RESPONSE TO REQUEST FOR ADDITIONAL INFORMATION

APR1400 Design Certification

RAI No.: 160-8174

SRP Section: 09.03.04 – Chemical and Volume Control System (PWR) (Including Boron Recovery System)

Figure 2.4.6-1 Chemical and Volume Control System

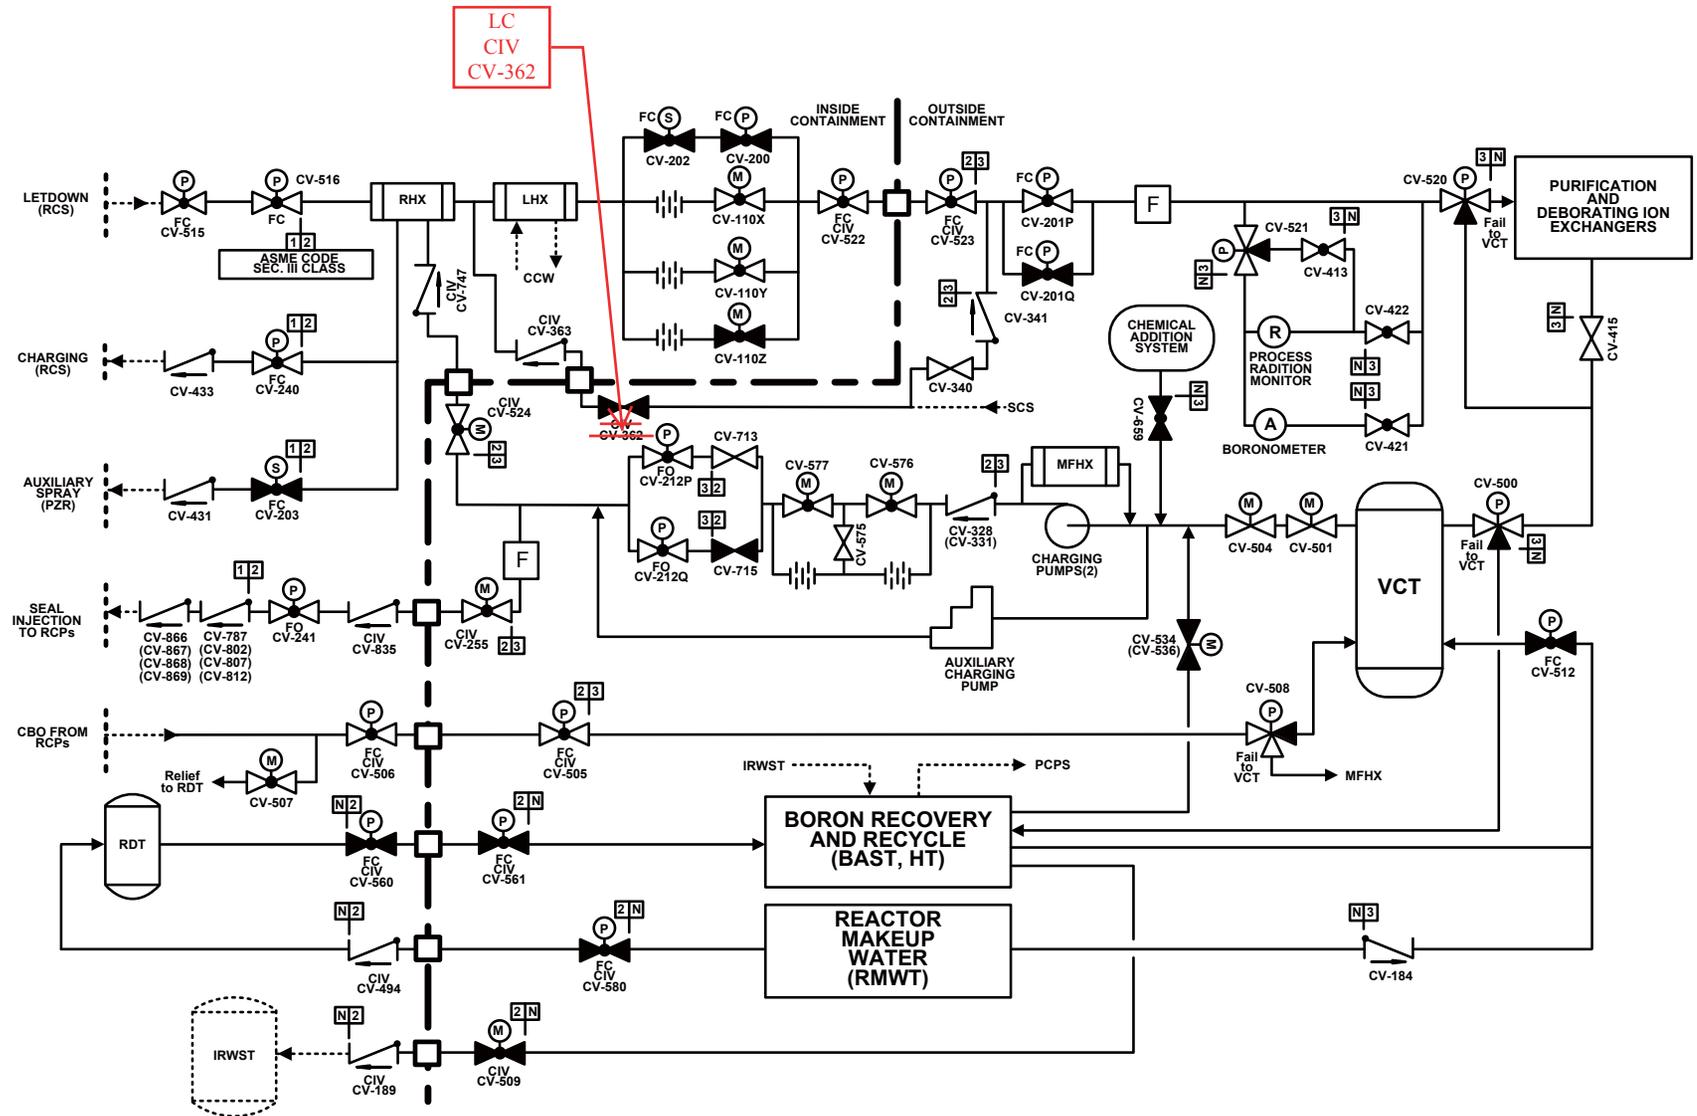
In DCD Tier 1, Figure 2.4.6-1, the staff noted that containment isolation valve, CV-362, was lacking indication of valve position status. However, in DCD Tier 2, Figure 9.3.4-1, the staff noted that CV-362 is locked closed during normal operation. Tier 1 information should be derived from and consistent with Tier 2 information.

The staff requests the applicant to update DCD Tier 1, Figure 2.4.6-1 to include valve position status of CV-362 consistent with what is shown in DCD Tier 2, Figure 9.3.4-1.

As shown in DCD Tier 2, Figure 9.3.4-1, CV-362 is locked closed during normal operation. DCD Tier 1, Figure 2.4.6-1 will be revised to make consistent with DCD Tier 2 information.

DCD Tier 1 Figure 2.4.6-1 will be revised as presented in Attachment.
